**SEWER PLAN & PROFILE**  
**MONROE STREET**

**MONROE PARK**  
 HORIZ SCALE 1"=40' VERT. SCALE 1"=4'

NO. 5-43  
 SHEET 2 OF 5

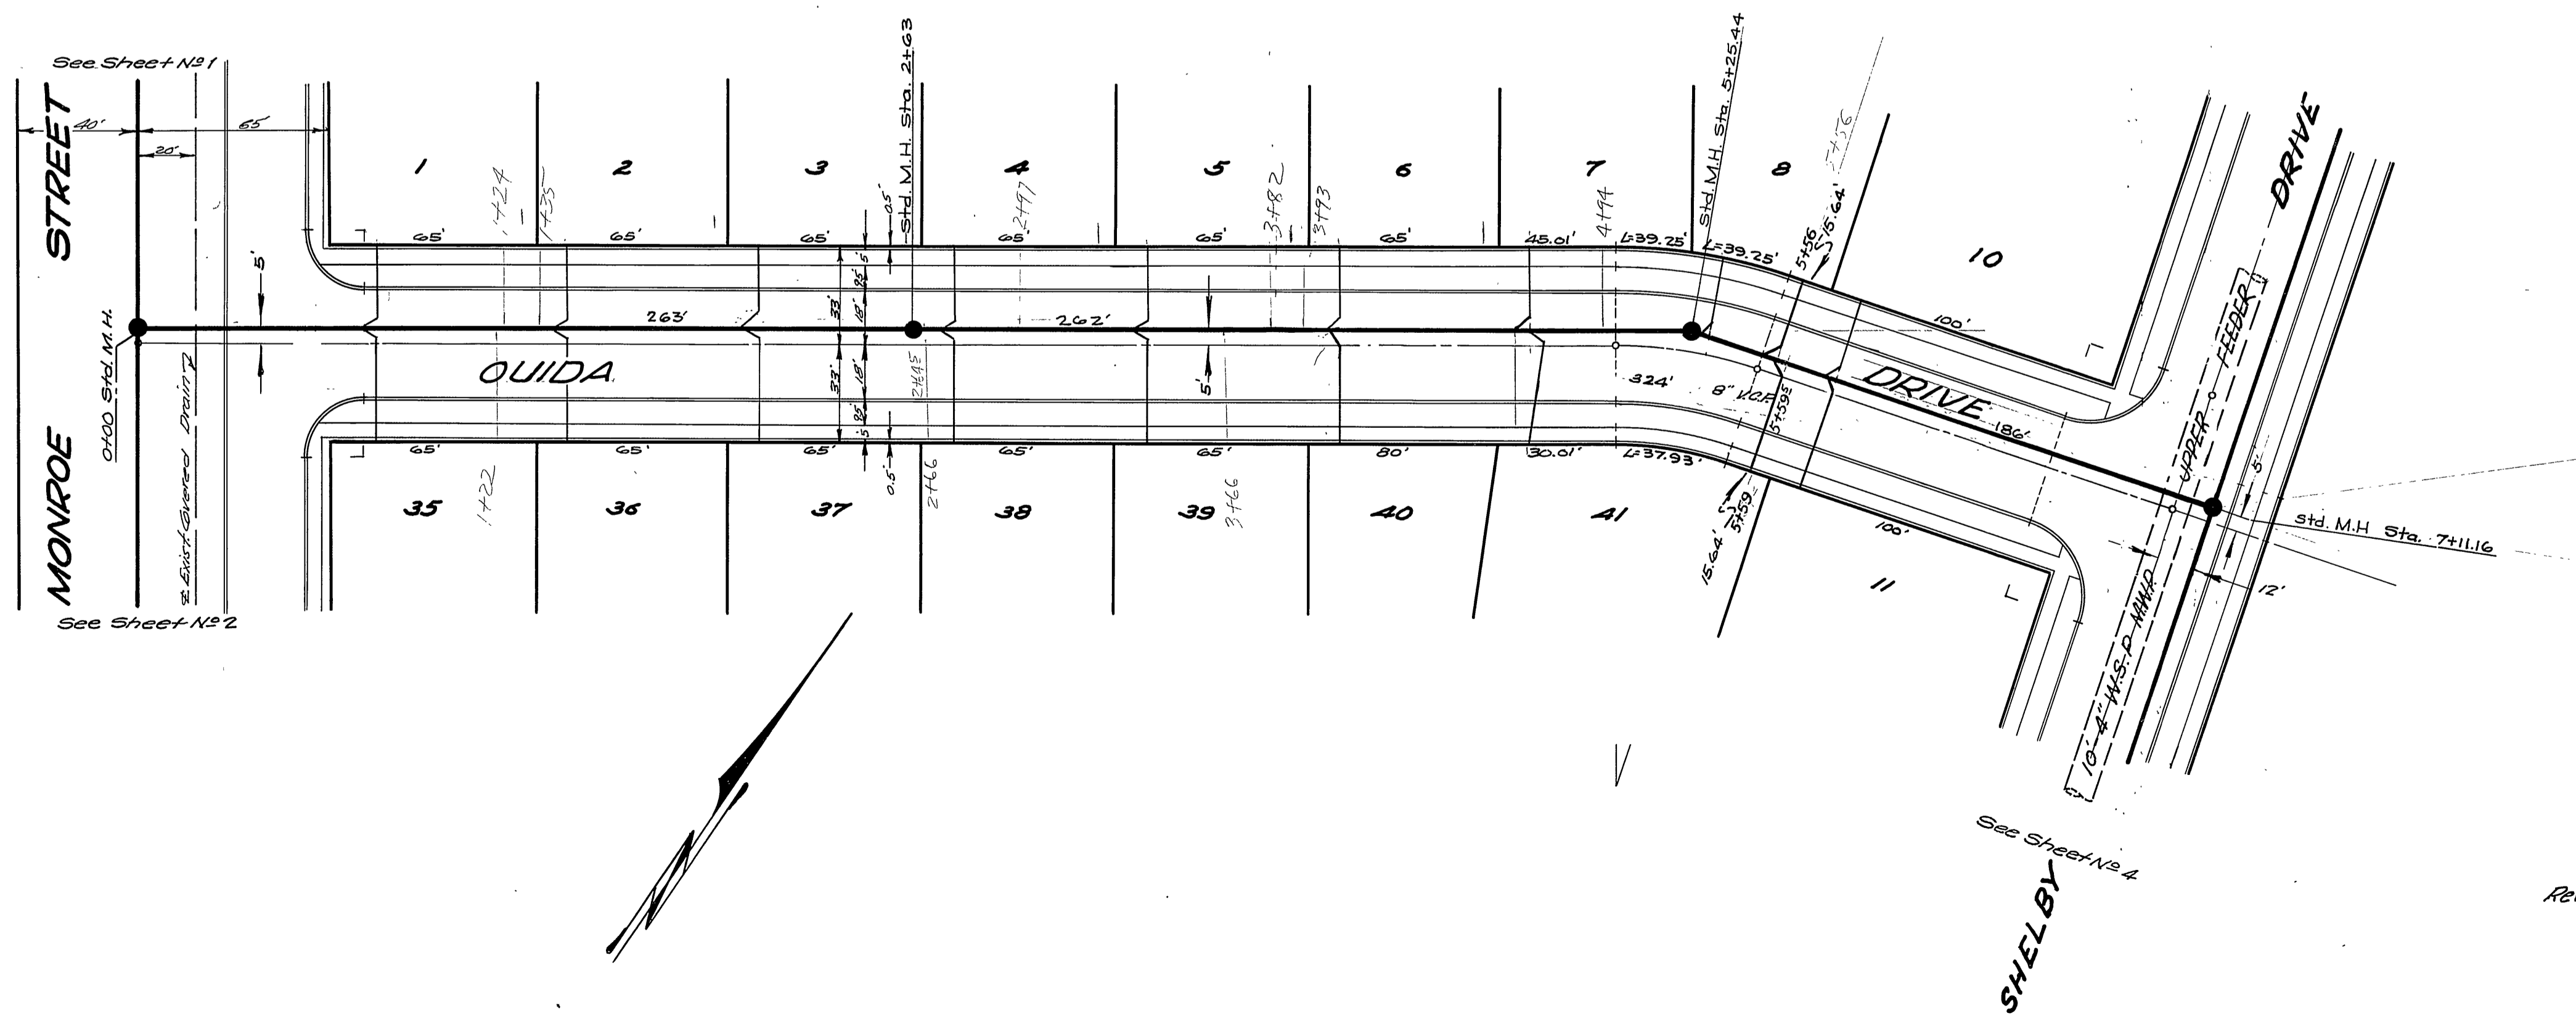
NOTE - Laterals to be located in the field.  
(SEE SEWER CARDS)  
LOT LINES INCORRECTLY PLOTTED - SEE PLAT.

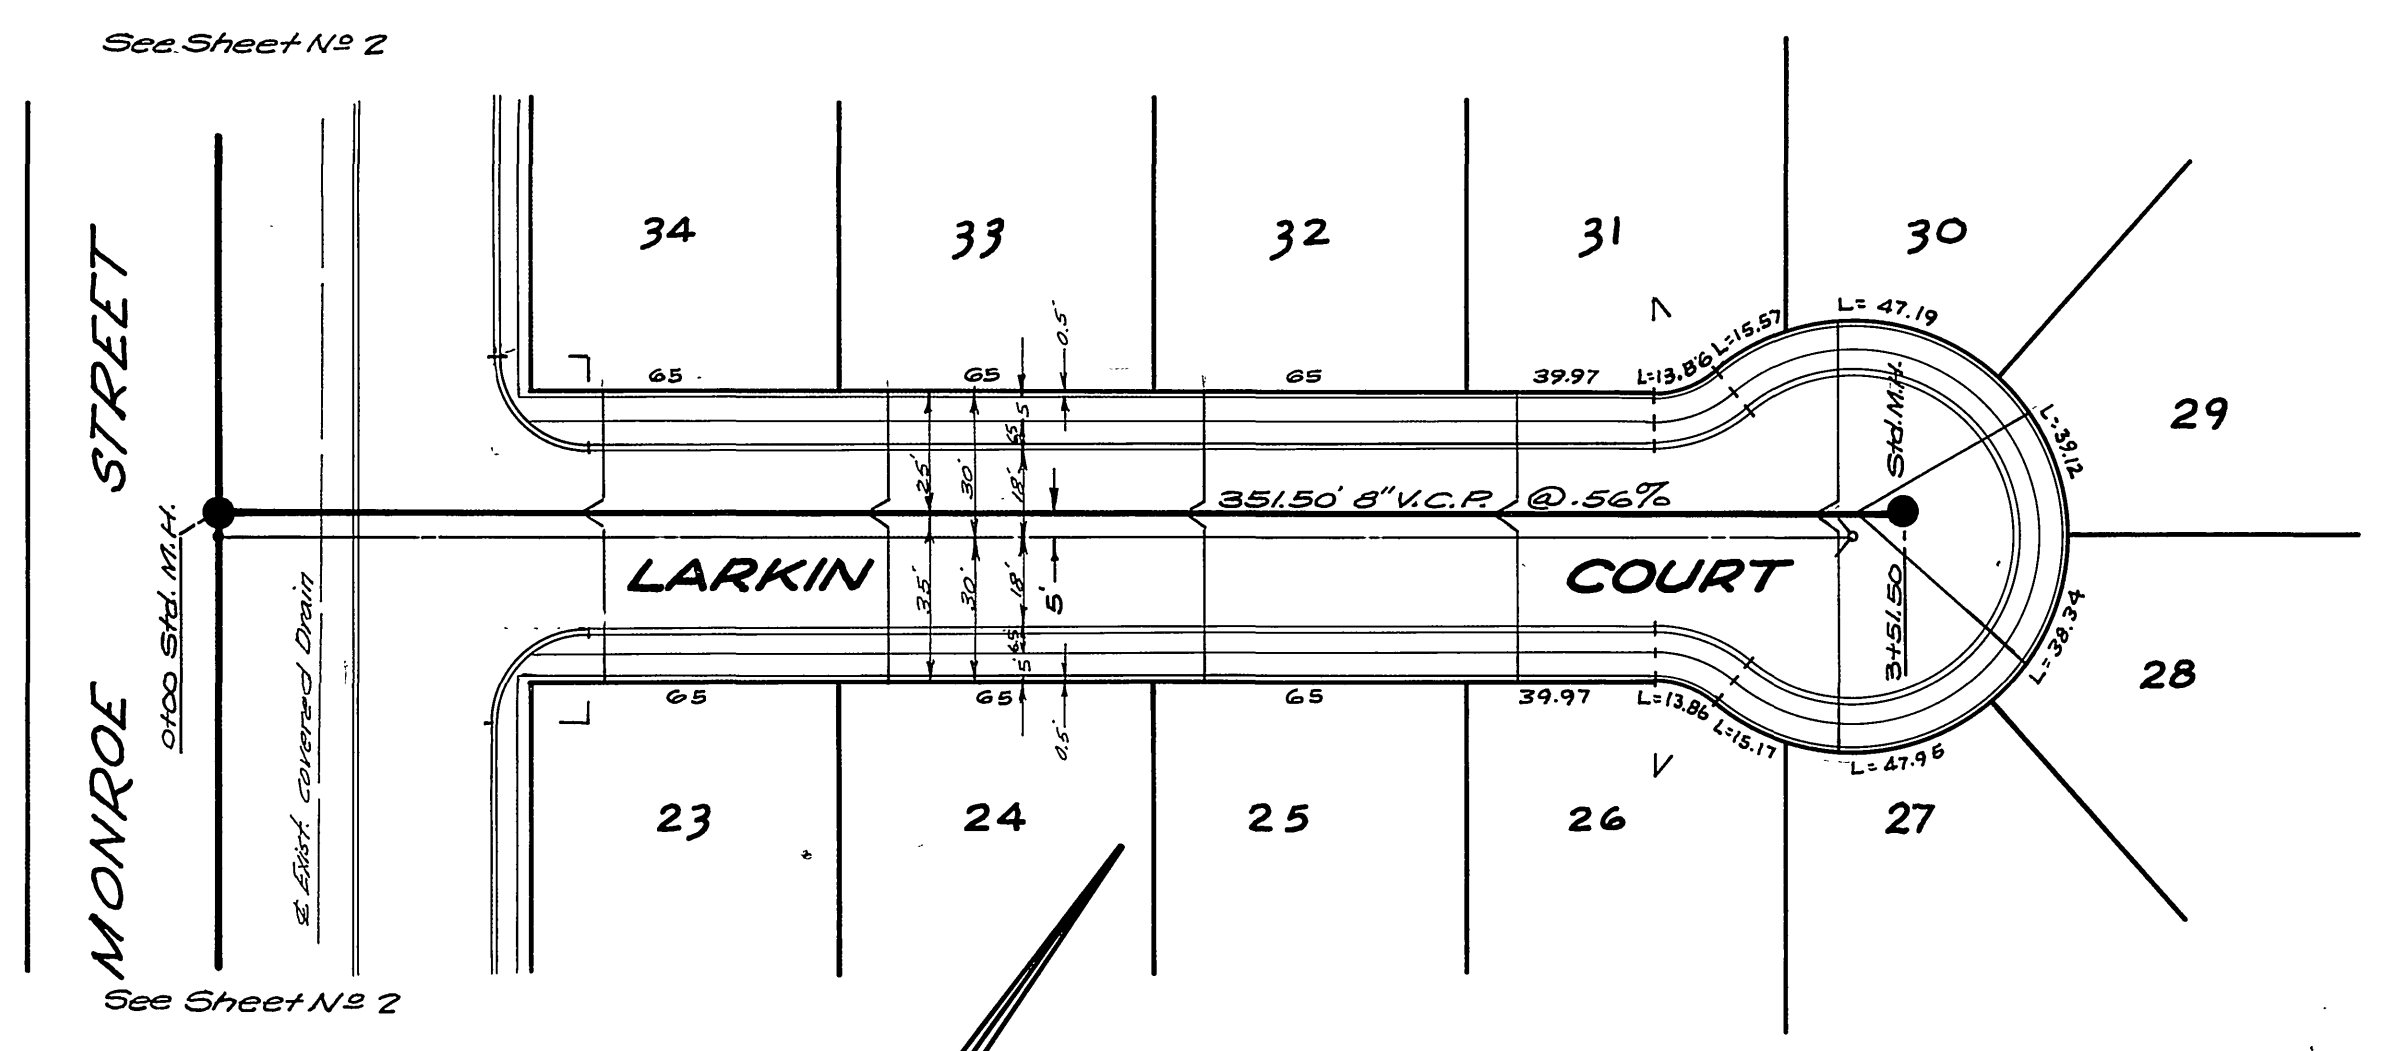
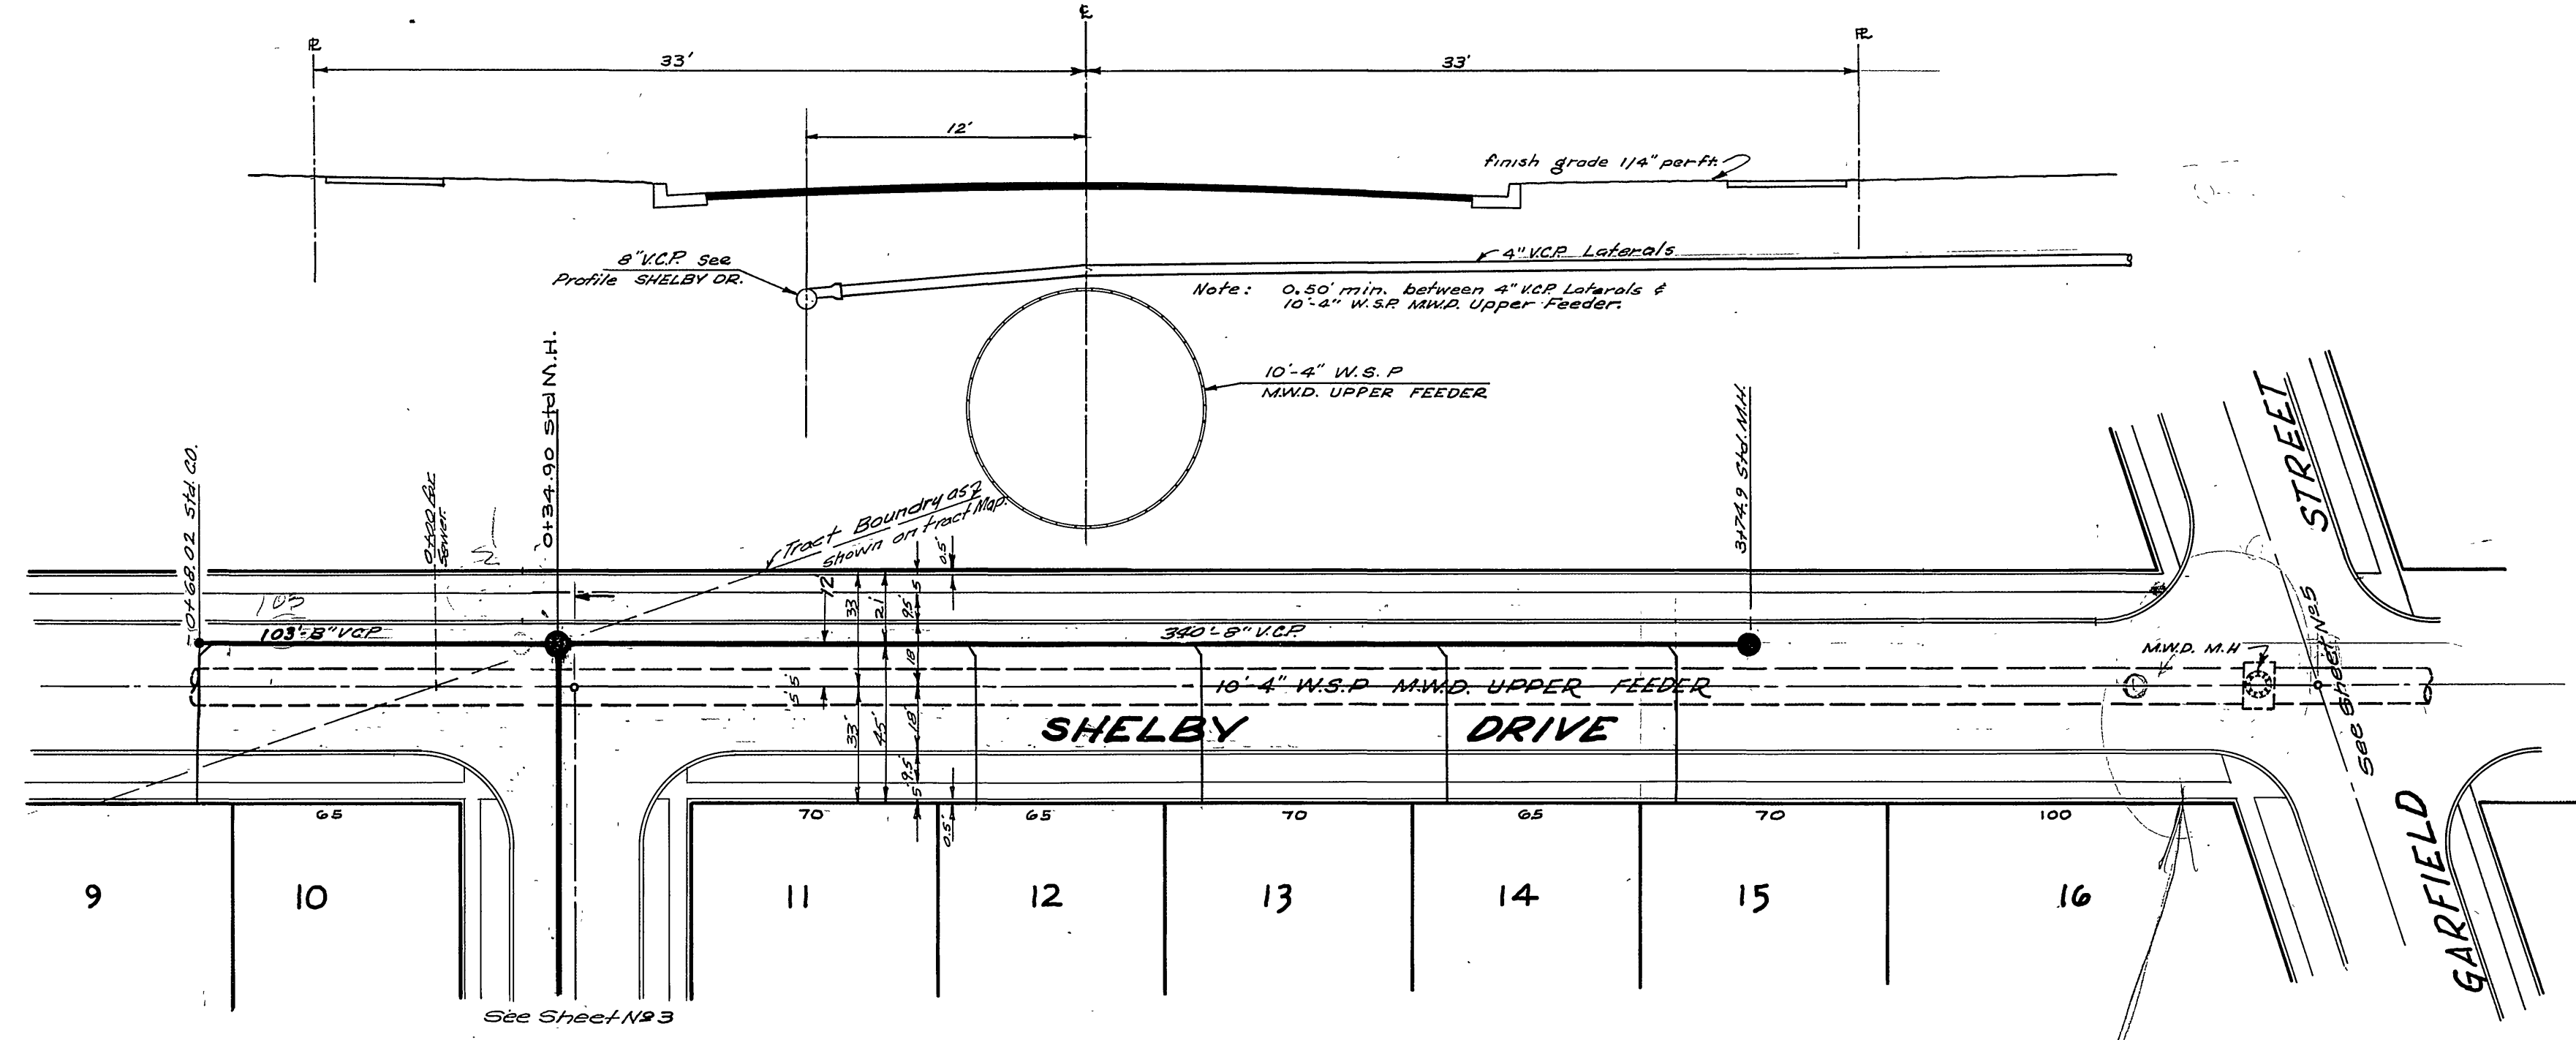
CORRECT  $\phi$  GARFIELD  
SHOULD BE 5736.70 (SEE PLAN)  
M.H. 11-21-72

M.H.  
M.W.D. SHOULD BE  
52.51' N. OF INTERSECTION

Revised *[Signature]* Date 10/19/76  
Director of Public Works
